Reply on review of our manuscript HESS-2017-434 "Impact of coastal forcing and groundwater recharge on the growth of fresh groundwater resources in a mega-scale beach nourishment"

Comments Referee #1

Comments Referee #2

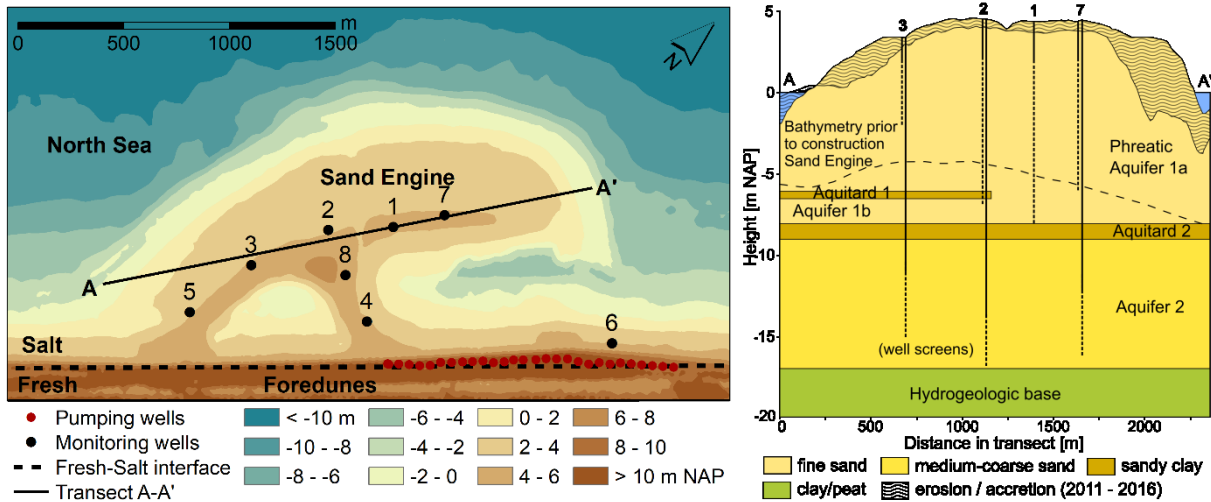
- P4, line 24-28: Vague, please add a figure to support this section

- P9, line 28-29: Please provide more information on this initial groundwater salinity (figure)
We have definitions of mentioned areas (e.g. foredunes) to Figure 2, and have added a dotted line to Figure 2 that signifies the initial salinity distribution (fresh/salt).

We have definitions of mentioned areas (e.g. foredunes) to Figure 2, and have added a dotted line to Figure 2 that signifies the initial salinity distribution (fresh/salt).

Figure 5. Observed and simulated water levels in the lagoon from 2-23 October 2014, which contains a fortnightly spring-neap tidal cycle and a storm surge around 22 October.

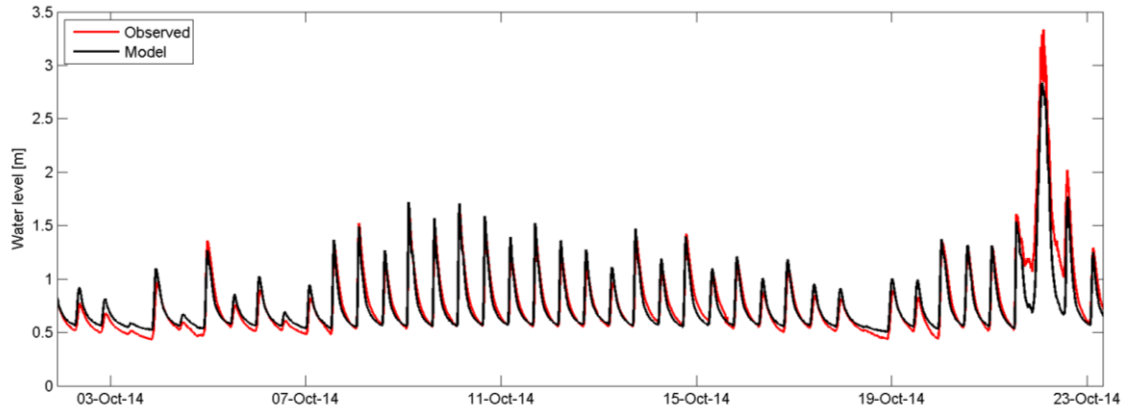
- P6, line 28: no water level measurements available in the lagoon?

Yes, in the lagoon we only had water levels for the period of 2 to 23 October 2014 (see Figure 5).
